REVISION #1 12-12-75 R.D.A.

CITY OF HARTFORD, CONNECTICUT DEPARTMENT OF PUBLIC WORKS BUREAU OF PUBLIC BUILDINGS			
REPAIR TO NEWFIELD AVE BRIDGE. STEEL CRADLE, HANDRAIL POSTS & CONC. WORK.			DWG. NO. 1
SUBMITTED Paul Anthony	RECOMMENDED William H. Ruse	APPROVED James J. Ruse	DATE 10-24-75
SCALE N.T.S.	DAYBOOK NO. 010544

SECTION A-A LKG. NORTH

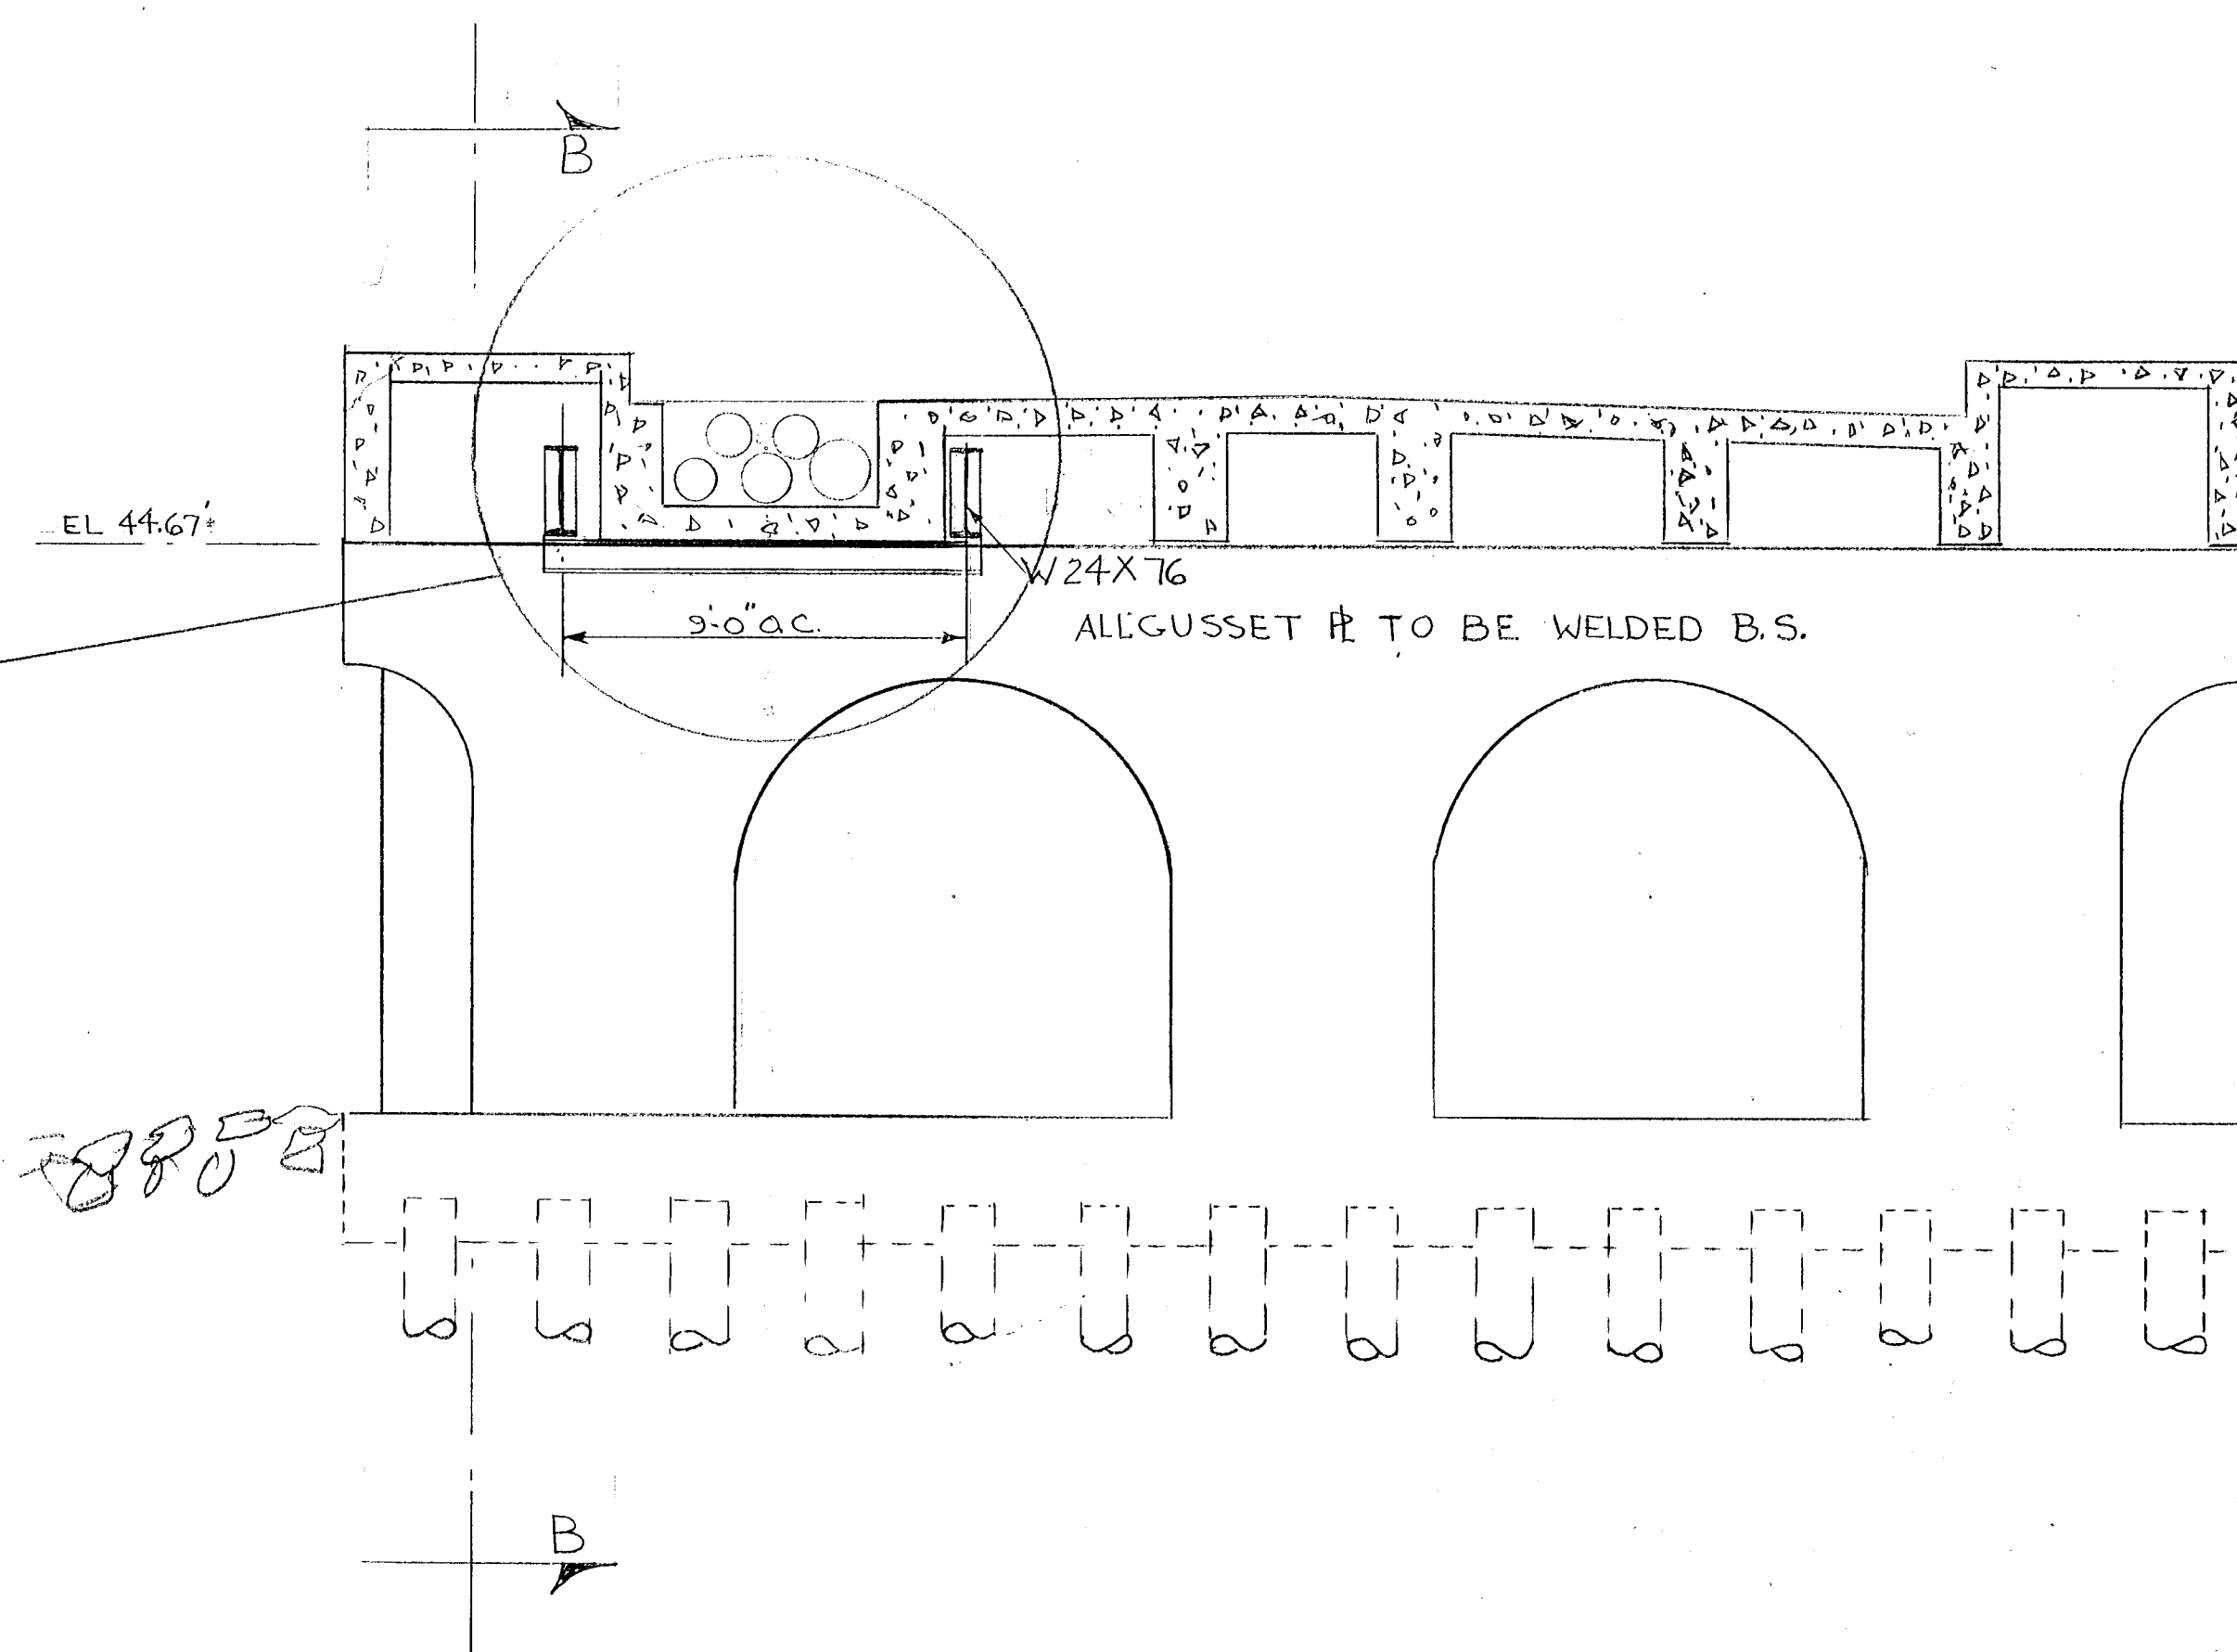
1. ADDED NOTE #5 IN GEN. NOTES.
2. ADDED NOTE & SHADED AREA TO DETAIL OF SECT. A-A
3. ADDED BASE & POLE DETAIL
